Perry Minor Subdivision

Files No. MISA-01-24-8998

PROJECT INFORMATION AND STAFF COMMENTS

TYPE OF REVIEW Referral of an Administrative Decision to

Figure 2: Feasibility Plan

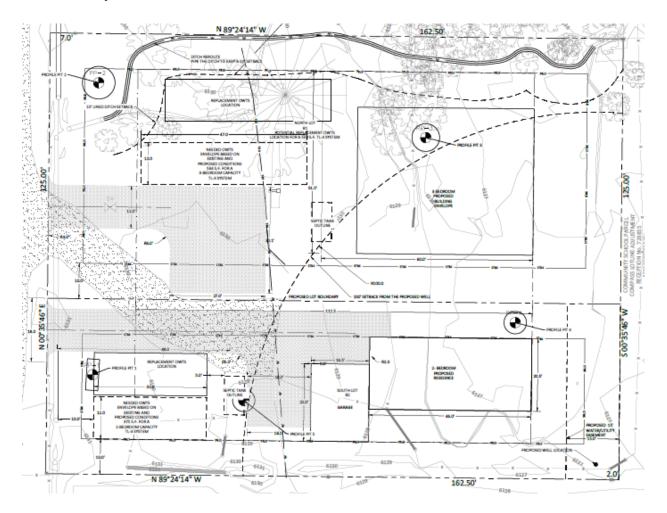
- A. **Garfield County Consulting Engineer, Mountain Cross Engineering:** Provided Comments on the following: OWTS setbacks need to be verified to adjacent properties. If ADU's are proposed, then OWTS systems will need to be designed for 4 units. Water quality and pump tests need to be performed.
- B. Garfield County Road and Bridge: No comments received
- C. Carbondale and Rural Fire Protection District: Impact fees will need to be paid.
- D. **Town of Carbondale:** Had no comments on the application.
- E. Garfield County Public Health: Provided two comment letters, first on July 23, 2024, requested more information on surrounding properties OWTS system locations and well locations. Noted that lots less than 1 acre is size are problematic.

The September 10, 2024 Comments noted: The applicant provided updated information as to neighboring properties and a site specific soil study for OWTS design. There appears to be room for the treatment areas but no area for replacement areas should they fail. Recommended denial of the waiver request

from Section 7-105 B.2.b. due to the size of the proposed lots being under one acre.
